Council Reference BE/41/13 Towncross Avenue Bognor Regis

**Response to WSCC Highways Consultation reply dated 14 May 2013 &
Neighbours representations received as at 11 June 2013**

Response to WSCC Highways Consultation Reply dated 14 May 2013

DRG NO TCA 2012 /03 SCALE 1:250 @ A2 DATE November 2012

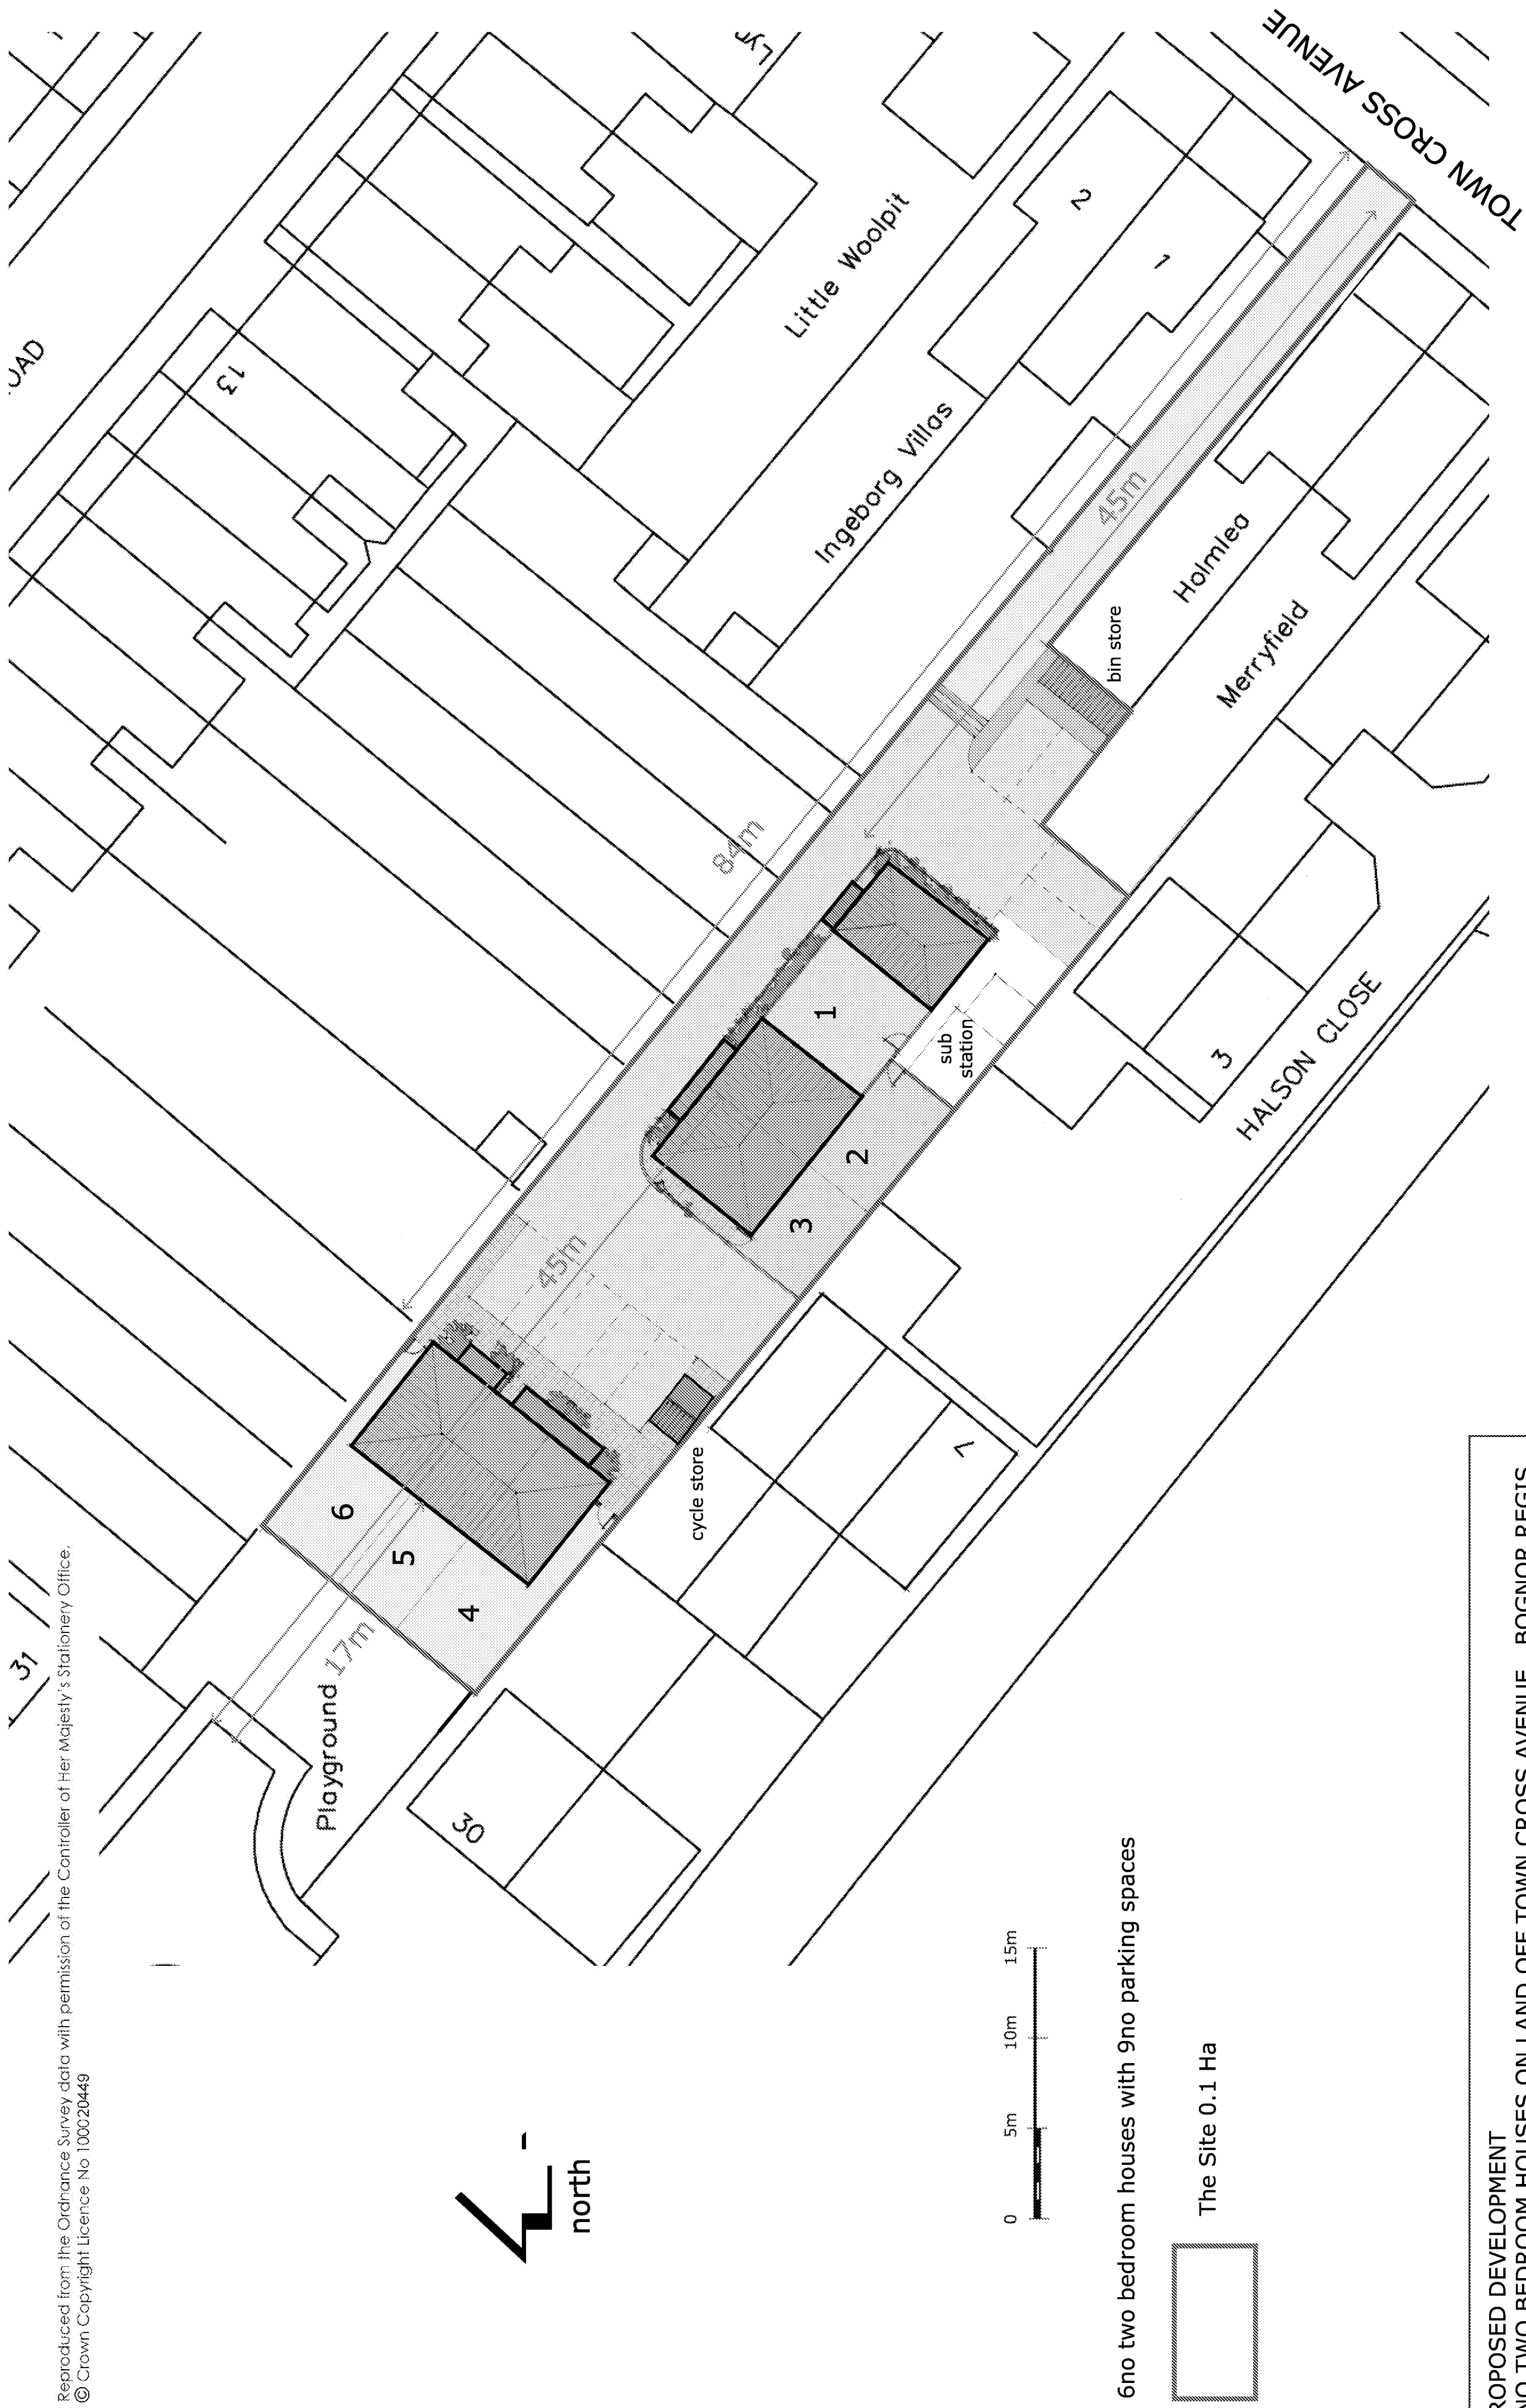
WSCC Comment: 1) Although the proposed access is existing, and the number of trips generated from 6 dwellings is unlikely to have any material impact on the highway. WSCC would like to know what visibility splays are achievable from this access onto the highway. The design and access statement indicates that the visibility splays will be within the applicants' control. These should be set back 2.4m from the centre of the carriage way (2m minimum) and drawn to the nearside kerb in both directions.

WSCC Comment: 2) The width of the access road has not been indicated and as a guess it appears to be too narrow or only just within guidance. We need clarification to make sure a fire appliance can enter and turn within the site in the event of a fire.

WSCC Comment 3) Please provide swept path diagrams showing how a fire appliance will move within the site. We need to know the appliance can enter the access road from the highway as well as being able to turn within the site without over running the existing kerbline. Guidance from the Fire and Rescue service act 2004 states: Cul-de-sacs - turning facilities should be provided on cul-de-sac roads exceeding 20m in length. This can be a hammerhead or turning circle designed on a minimum road width of 3.1m. This turning facility should be provided within 20m of the end of the access road so that fire service vehicles do not have to reverse more than 20m.

WSCC Comment: 4) Please provide evidence of where bicycles will be stored that is secure and covered. This development would require 1 space per dwelling.

Response: It is noted that WSCC Highways raise no objection to the principle of the development proposed as it is agreed that the proposed development would be unlikely to have any material impact on the highway due to the limited number of vehicular trips likely to be generated by the 6 dwellings proposed which would be reduction from those that the existing use might attract when in full use. Nonetheless the proposed visibility splays achievable without any alteration of the existing access are shown on the attached Block Plan.

Response: The width of the existing access can be scaled from the submitted plans and it is not proposed that this should be reduced in width. The existing access has been more than sufficient in width to allow modern commercial vehicles and if necessary a Fire Appliance to enter and leave the site for well over 30 years.

Response: There would be inadequate space within the development as proposed for a Fire Appliance to enter and turn within the site but this is not necessary in any event. The attached plan shows that there would be access to the proposed dwellings for a Pump appliance within 45 metres as a Fire Appliance could be parked on the public highway at either end of the site. Moreover it is in any case intended and expected that a Fire Hydrant would be provided within the site in accordance with the Building Regulations (and such provision could be made in response to any condition imposed on any planning permission granted in any case) which would reduce the length of any Hose pipe run still further. This is a very common circumstance

Response: See Block Plan already submitted.
